# UNITED STATES PATENT AND TRADEMARK OFFICE

APPLICATION NO.	FILING DATE	FIRST NAMED INVENTOR	ATTORNEY DOCKET NO.	CONFIRMATION NO.
09/915,385	07/27/2001	Mikihiro Yokozeki	211895US8	9746

**Office Action Summary**

## **DETAILED ACTION**

FIG. 4  
PRIOR ART

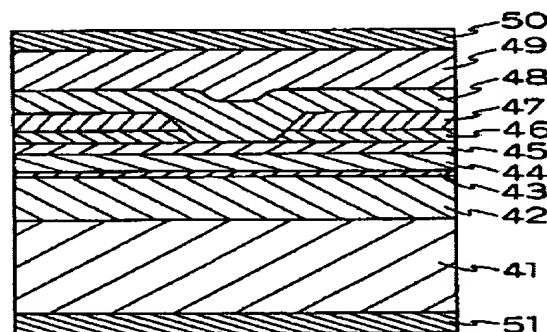
In figure 4 Mushiage illustrates of a known prior art semiconductor laser having an etch stop layer (45) composed of InGaP, a first semiconductor layer (46) composed of AlInP and a second semiconductor layer (47) composed of GaAs, where semiconductor layers are etched until the etch stop layer. Semiconductor layer (46)

contains aluminum, semiconductor layer (47) does not contain aluminum or phosphorus and the etch stop layer contains phosphorus, as described in column 1 lines 43-50.

Mushiage et al does not disclose the claimed sequence of depositing the etch stop layer and the semiconductor layers as recited in claims 1 and 3.

However, by original presentation applicant had recited a particular sequence of depositing the claimed layers and by amendment has rearrange the sequence of depositing the claimed layers, which suggest that absence of new or unexpected result the sequence of depositing the layers is a design preference and renders the preferred sequence as obvious. *Ex parte Rubin*, 128 USPQ 440 (Bd. App. 1959); *In re Burhans*, 154 F.2d 690, 69 USPQ 330 (CCPA 1946) and *In re Gibson*, 39 F2d 975, 5 USPQ 230 (CCPA 1930)

**FIG.2**

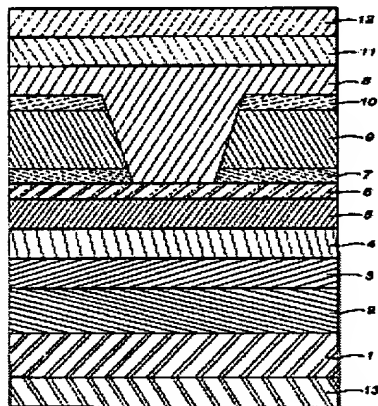
In figure 2 Horie et al illustrates a semiconductor laser having a second etch stop layer (6), a first etch stop layer (7), a first semiconductor layer (9) and second

semiconductor layer (10), where the layers are etched until the etch stop layer (6), as described in column 5 and example 1 in column 7.

Therefore, it would have been obvious to a person having ordinary skill in the art at the time of the invention was made to provide the semiconductor laser of Mushiage et al with a second etch stop layer because it would provide for a precise fabrication of the current injection region as suggested by Horie in column 5 lines 7-9.
